Re: BAR Case TLHP-2009-0079 (Amendments to TLHP-2006-0046); Conditional Approval, Fort Evans Plaza II, Comprehensive Sign Plan

CASE # TLHP - 2009 - 0079

AMENDMENTS TO TLHP-2006-0046

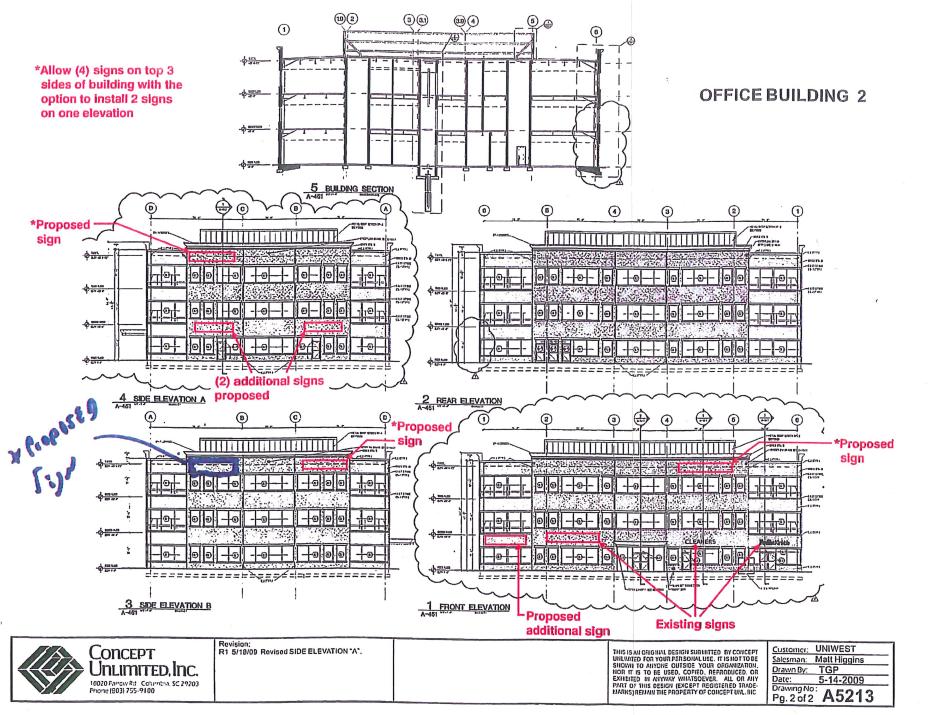
- 1. The number of signs between the first and second stories of the office buildings will be increased from three (3) to six (6), and their placement will be symmetrical on the two elevations in accordance with the plans dated 14 May 2009. The type of sign to be used in this location will be as approved in the original SCP approved on 15 May 2006 (TLHP-2006-0046)
- 2. The signs on the cornice level will not be illuminated.
- 3. The number of signs at the cornice level will be increased from two (2) to four (4), and their placement will be in accordance with the plans dated 14 May 2009. The type of sign to be used in this location will be as approved in the original CSP approved on 15 May 2006 (TLHP-2006-0046)
- 4. A revised illustration will be provided to staff.
- 5. The motion and conditions are based on the findings stated in the staff report dated 15 June 2009.
